Stage 2 Road Safety Audit Report (Detailed Design)

**West Ashton,
Leap Gate – West Ashton Road
New Residential Development
S278 Highway Access Works**

**Produced for:
Persimmon Wessex**

Date: 30th May 2024

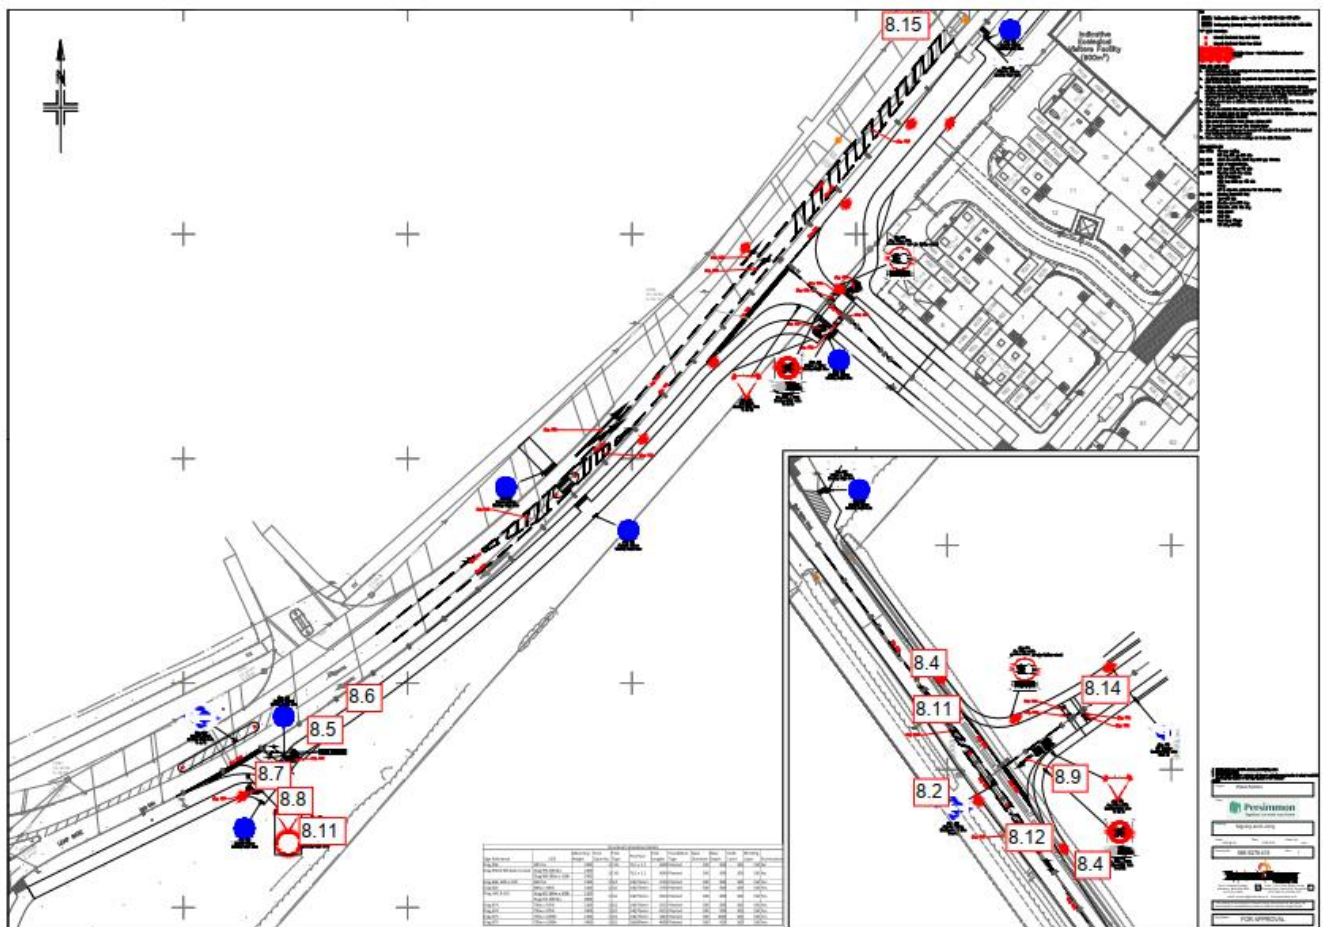
8.1 *Problem* (Item B1.13)	
Location:	All 3 junctions
Summary:	No vehicle tracking analysis produced for new junctions
There are three new junctions proposed. There has been no vehicle tracking analysis produced to show that the junctions can be used safely by turning vehicles. Produce vehicle tracking analysis to show junctions can be used safely by vehicles	
TYPE OF CONFLICT/COLLISION	
Risk of vehicles unable to turn safely at junctions	
RECOMMENDATION	
Produce vehicle tracking analysis to show vehicles can be used safely by vehicles

8.2 *Problem* (Item B1.13)	
Location:	West Ashton Road /Junction 3
Summary:	Existing field access not being retained opposite junction 3

8.3 *Problem* (Item B2.1)	
Location:	All 3 junctions
Summary:	No visibility splays detailed at junctions
There are 3 new junctions detailed without any visibility splays detailed for vehicles exiting the side roads. Ensure required unobstructed visibility splays are provided to enable vehicles exiting side roads to see oncoming vehicles	
TYPE OF CONFLICT/COLLISION	
Risk of vehicle collisions due to reduced visibility splay	
RECOMMENDATION	
Ensure required unobstructed visibility splays are provided to enable vehicles exiting side roads to see oncoming vehicles

Location:	West Ashton Road /Junction 3
Summary:	Verge hedge obstructs visibility for vehicles exiting junction 3
A new side road junction is detailed. There is verge vegetation that obstructs the visibility of oncoming vehicles for vehicles exiting the side road. Remove vegetation where it is within the required visibility splay for vehicles exiting the side road	
TYPE OF CONFLICT/COLLISION	
Risk of vehicle collisions due to obstructed visibility when exiting side road	
RECOMMENDATION	
Remove vegetation where it is within the required visibility splay for vehicles exiting the side road

8.5 *Problem* (Item B3.2)	
Location:	Leap Gate approach to junction 2
Summary:	ADS sign obstructs visibility for vehicles exiting side road at junction 2

8.6 *Problem* (Item B3.3)	
Location:	Leap Gate approach to junction 2
Summary:	No Right Turn sign required on approach to junction 2
A new junction is detailed with no right turn proposed on the junction. There is no regulatory NO RIGHT TURN sign detailed on the approach to the junction to tell approaching drivers that they cannot turn left. Provide required NO RIGHT TURN sign	
TYPE OF CONFLICT/COLLISION	
Risk of vehicles turning left illegally at junction	
RECOMMENDATION	
Provide required NO RIGHT TURN sign where required

8.7 *Problem* (Item B3.3)	
Location:	Leap Gate /Junction 2
Summary:	No Entry signs required on access into side road at junction 2 from Leap Gate
There is a new side road junction detailed with one way exiting the development. There are no NO ENTRY signs detailed at the junction as legally required to tell drivers that they cannot enter the side road. Provide required NO ENTRY signs at junction	
TYPE OF CONFLICT/COLLISION	
Risk of vehicles turning into side road due to lack of signage	
RECOMMENDATION	
Provide required NO ENTRY signs at junction

8.8 *Problem* (Item B3.3)	
Location:	Leap Gate /Junction 2
Summary:	Speed limit terminal signs required on side road exit at junction 2
A new side road junction is detailed with the side road restricted to 20mph forming part of the adjacent development. There are no speed limit terminal signs on the side road informing drivers that they are leaving the 20mph Zone at accessing a 50mph speed limit road. Provide required speed limit signs on side road at junction	
TYPE OF CONFLICT/COLLISION	
Risk of drivers exiting side road unaware of raised speed limit	
RECOMMENDATION	
Provide required speed limit signs on side road at junction

8.9 *Problem* (Item B3.3)	
Location:	West Ashton Road n/Junction 3
Summary:	No right turn sign required on side road as per design for junction 2
A new side road junction is detailed with a no right turn . A NO RIGHT TURN sign is required on the side road to tell drivers they cannot turn right when exiting side road as per junction 2. Provide required NO RIGHT TURN sign on side road	
TYPE OF CONFLICT/COLLISION	
Risk of vehicle turning right when exiting side road	
RECOMMENDATION	
Provide required NO RIGHT TURN sign on side road

8.10 *Problem* (Item B3.4)	
Location:	All 3 junctions
Summary:	Carriageway markings detailed are incorrect as they are for roads with a speed limit of 40mph or less
New carriageway markings are detailed along Leap Gate and West Ashton Road that are incorrect as they are for roads with speed limits of 40mph or less. Leap Gate and West Ashton Roads are restricted to 50mph speed limits so the larger markings are required as per TSM Chapter 5 to ensure they can be seen by drivers. Amend design to show correct size markings	
TYPE OF CONFLICT/COLLISION	
Risk of incorrect road markings causing problems for road users	
RECOMMENDATION	
Amend design to show correct size markings

8.11 *Problem* (Item B3.4)	
Location:	Leap Gate /Junction 2
Summary:	TURN LEFT markings required on approach to give way at junction 2
A new side road junction is detailed with restricted left turn only exit from the side road. TURN LEFT and arrow markings are required on the side road approach to the give way to tell drivers to turn left	
TYPE OF CONFLICT/COLLISION	
Risk of driver turning right at junction	
RECOMMENDATION	
Provide required TRUN LEFT and Arrow markings on side road

8.12 *Problem* (Item B3.4)	
Location:	West Ashton Road/Junction 3
Summary:	Reduced length of deflection on approach to traffic island at junction 3 needs to be preferred 1 in 45 (TSM Chapter 5)
There is central hatching detailed on the approach to the new traffic island with reduced length of deflection that is not as the preferred 1 in 45 as per TSM Chapter 5. Amend design to provide required deflection on approaches to island.	
TYPE OF CONFLICT/COLLISION	
Risk of vehicle collisions with traffic island	
RECOMMENDATION	
Amend design to provide required deflection on approaches to island.

8.13 *Problem* (Item B4.2)	
Location:	All 3 junctions
Summary:	No visibility splays detailed at pedestrian crossing points
There are pedestrian crossing points detailed at all three junctions. There are no clear visibility splays detailed at these pedestrian crossing points to ensure adequate intervisibility at the crossing points between pedestrians and vehicles. Provide required clear visibility splays at all pedestrian crossing points	
TYPE OF CONFLICT/COLLISION	
Risk of pedestrian collisions with vehicles due to inadequate visibility at pedestrian crossing points	
RECOMMENDATION	
Provide required clear visibility splays at all pedestrian crossing points

8.14 *Problem* (Item B4.2)	
Location:	Development access road junction 3
Summary:	No tactile paving detailed at pedestrian crossing point across side road at junction 3
There is a pedestrian crossing point detailed across the development access road without the required tactile paving to enable the crossing to be used safely by visually impaired pedestrians. Provide the required tactile paving at the pedestrian crossing point.	
TYPE OF CONFLICT/COLLISION	
Risk of visually impaired pedestrians unable to cross over road safely between drooped kerbs	
RECOMMENDATION	
Provide the required tactile paving at the pedestrian crossing point.

8.15 *Problem* (Item B4.2)	
Location:	Leap Gate / Pedestrian /cycle crossing point
Summary:	Existing End of Cycle Route sign needs to be removed as cycle path extended across road
